**NSLPP MEETING HELD ON 02/06/2021**

ADDRESS/WARD: 12 Fernhurst Avenue, Cremorne (V)**APPLICATION No:** DA 84/21**PROPOSAL:** Alterations and additions including first floor addition**PLANS REF:**

AUTHOR: Thomas Holman, Assessment Officer**DATE OF REPORT:** 23 April 2021**DATE LODGED:** 31 March 2021**RECOMMENDATION:** Approval

Figure 1 – Existing Roof Plan – EX101 A (left) and Proposed Roof Plan – DA102 B (right)

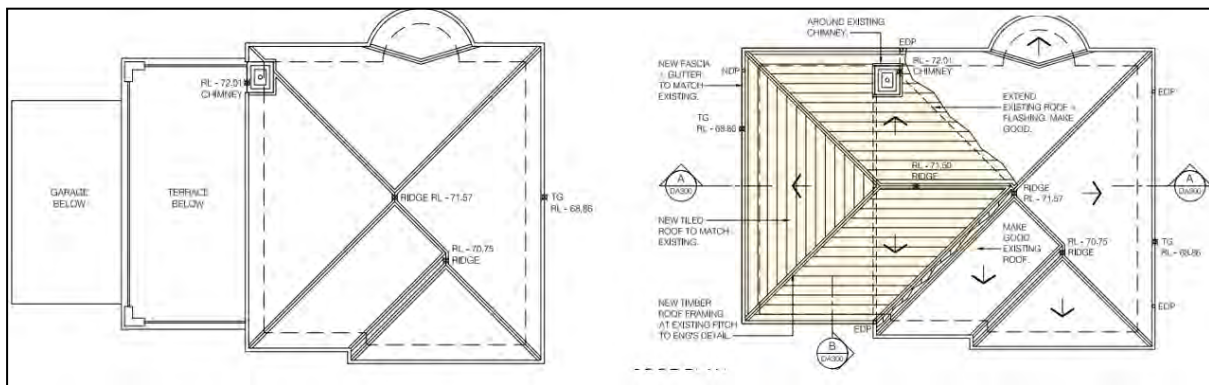
- Construction of a first floor addition over an existing terrace.
- The first floor addition will provide a master bedroom, ensuite and walk in robe.
- The existing bedroom 2 doors are to be bricked up and made good.
- Access to the master bedroom will be via a new opening from the existing first floor hallway.
- The first floor addition elevations will comprise brick to match the existing dwelling and a new tiled hipped roof to match existing roof.
- Window openings for the addition include a 2.75m² north facing window, 1.54m² west facing window and a 0.54m² east facing window.

Figure 12 – Elevation Shadow Diagram at 3pm on 21 June (left) and photo of the existing elevation of 14 Fernhurst Avenue (right)

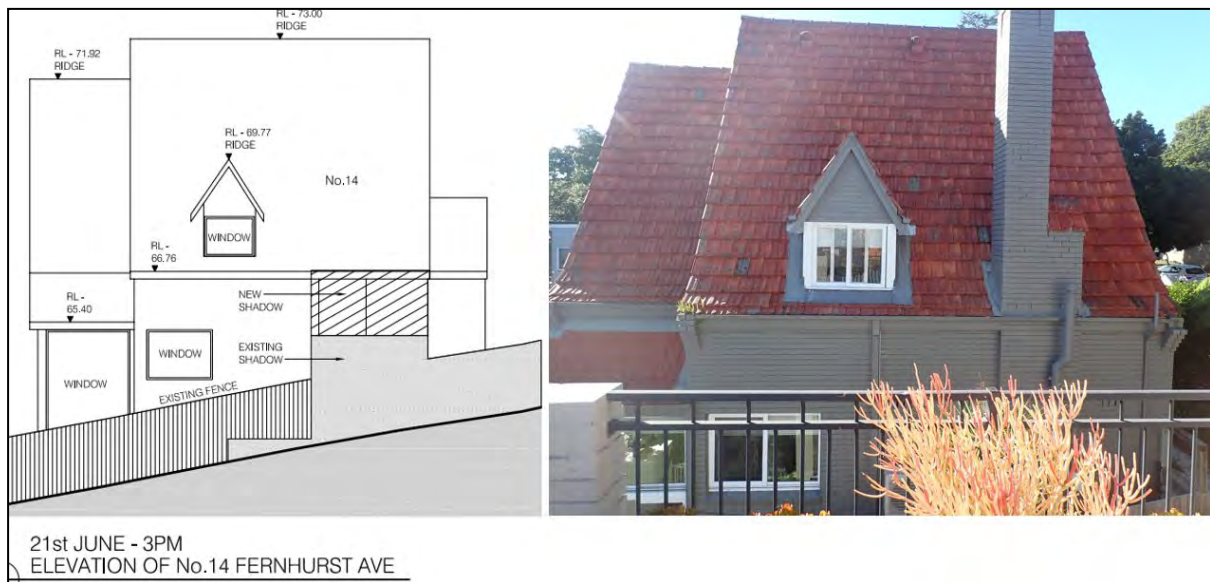
Shadow diagrams prepared by Group Architects assess the extent of shadow from the proposed development on 21st June (mid-winter) when the potential for shadows are at their greatest in the year. The shadow diagrams confirm the proposed first floor addition would have a marginal increase in shadow cast at 9am within the subject site and the footpath within Fernhurst Avenue. At midday minimal additional shadow will be cast from the first floor addition due to its siting concealed on the northern elevation of the dwelling not protruding beyond the dwelling roof ridge or elevations. At 3pm additional shadows cast would not result in a loss of solar access to habitable windows of the adjoining property 14 Fernhurst Avenue therefore having a nil impact on the adjoining property. Elevation shadow diagrams confirm the additional shadow at 3pm (mid-winter) would be cast over the existing elevation of 14 Fernhurst Avenue but not affecting windows of the property (Figure 12).

Overall, the first floor addition in the morning and afternoon at mid-winter would have a minimal impact to surrounding properties and streets and no impact at midday to the streetscape or adjoining properties.

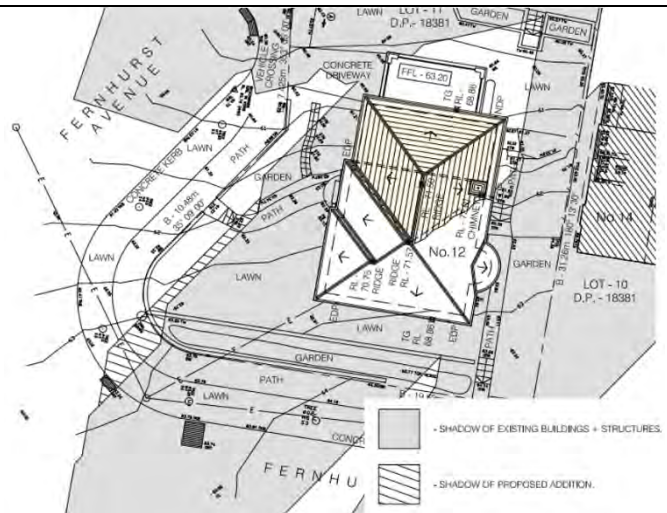
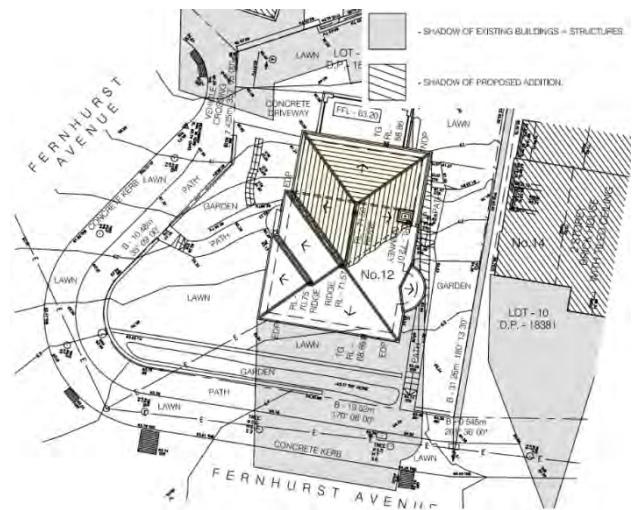
1.3.7 Solar Access	Yes	The shadow diagrams prepared by Group Architects confirm the proposed first floor addition would have marginal increases in shadow cast at 9am predominantly contained within the subject site and footpath of Fernhurst Avenue.

At midday no additional shadow will be cast from the first floor addition due to its siting concealed on the northern elevation of the dwelling not protruding beyond the dwelling roof ridge or elevations.

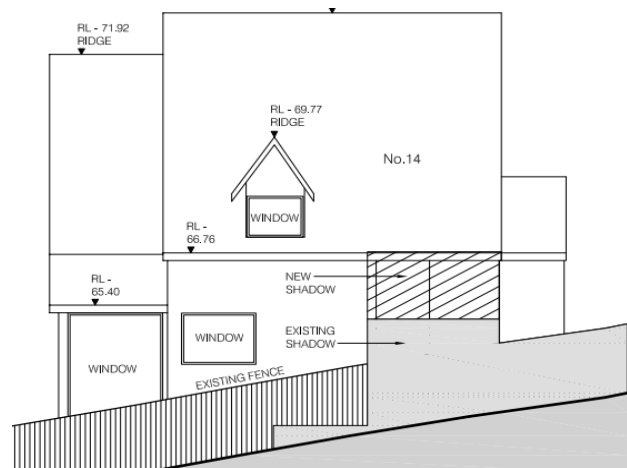
At 3pm additional shadows cast over the adjoining 14 Fernhurst Avenue would not result in a loss of solar access to habitable windows of the adjoining property therefore having a no impact on the adjoining property access to sunlight.

Overall, the first floor addition at mid-winter would have a minimal impact throughout the day on surrounding properties and streets and no impact at midday.

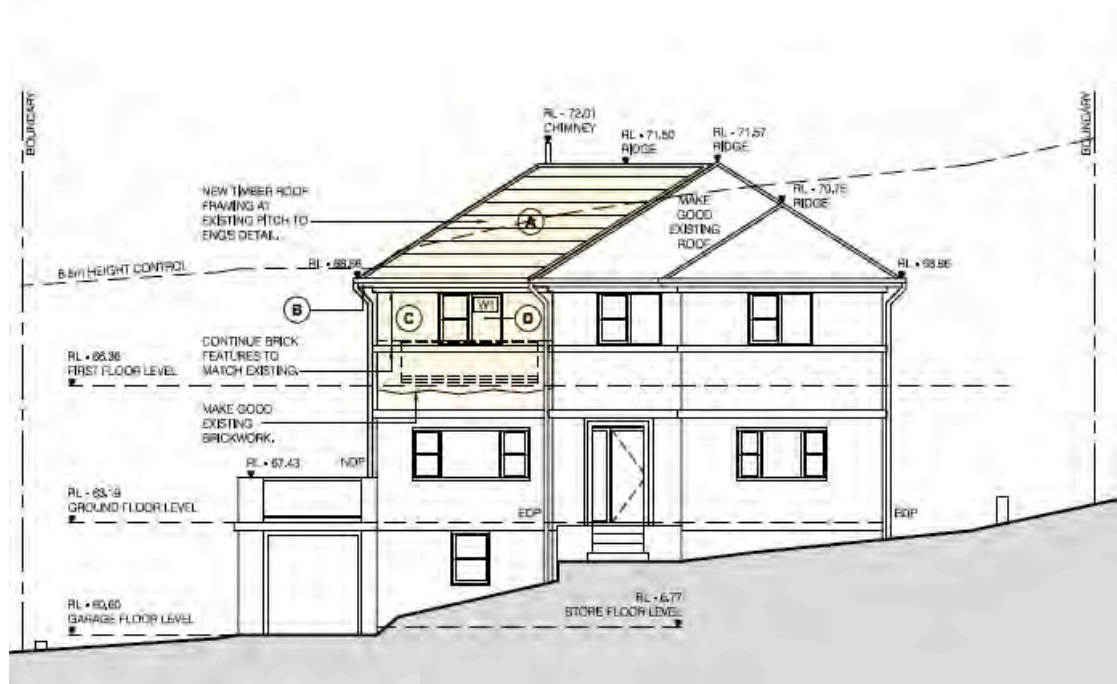
The following extract from the western elevation shows the 8.5m height line plotted relative to the existing ground level along the face of the elevation.
